Purpose of Meeting: Third Quarter Meeting 2021

- c. Deck curb hoop bar details –
- New bar bends for fascia hoop bars have been developed for use with and without precast panels.
 - A new bend was also developed for short overhang widths.
 - Bars N1 and N12 should be used, see detail below and detail at the end of the meeting notes.
 - The new bar marks and diagram are on the CADD cell library.
 - Everyone is to use the standard dimension shown for the bar mark N1 and N12.
 - Do not use bar mark **S5** since this is a strirrup bar bend which has smaller radii for the bends. We call out a larger radius (2.5") for the hoop bar bend.

N1

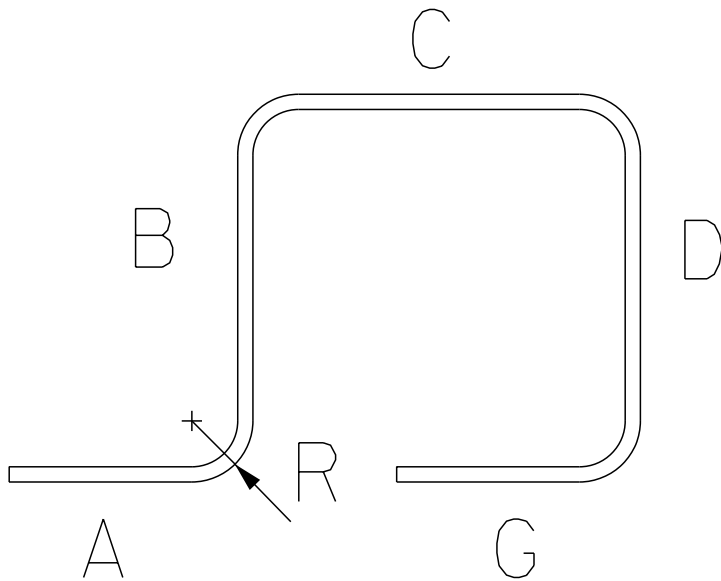
New standard 2-ft curb hoop bar. Replaces old N1 detail.

All dimensions are to outside of bar (#5)

A & G = 10"

B & D = to be calculated by designer

C = 1'-4"

R = 2.5"

N12

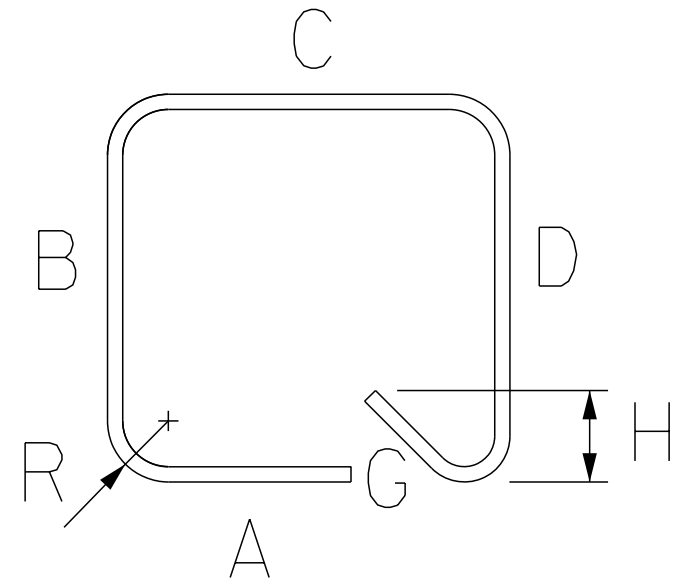
New short overhang curb hoop bar detail:

All dimensions are to outside of bar (#5)

A = 10"

B & D = to be calculated by designer

C = 1'-4"

R = 2.5", G = 5.5", H = 3.75"
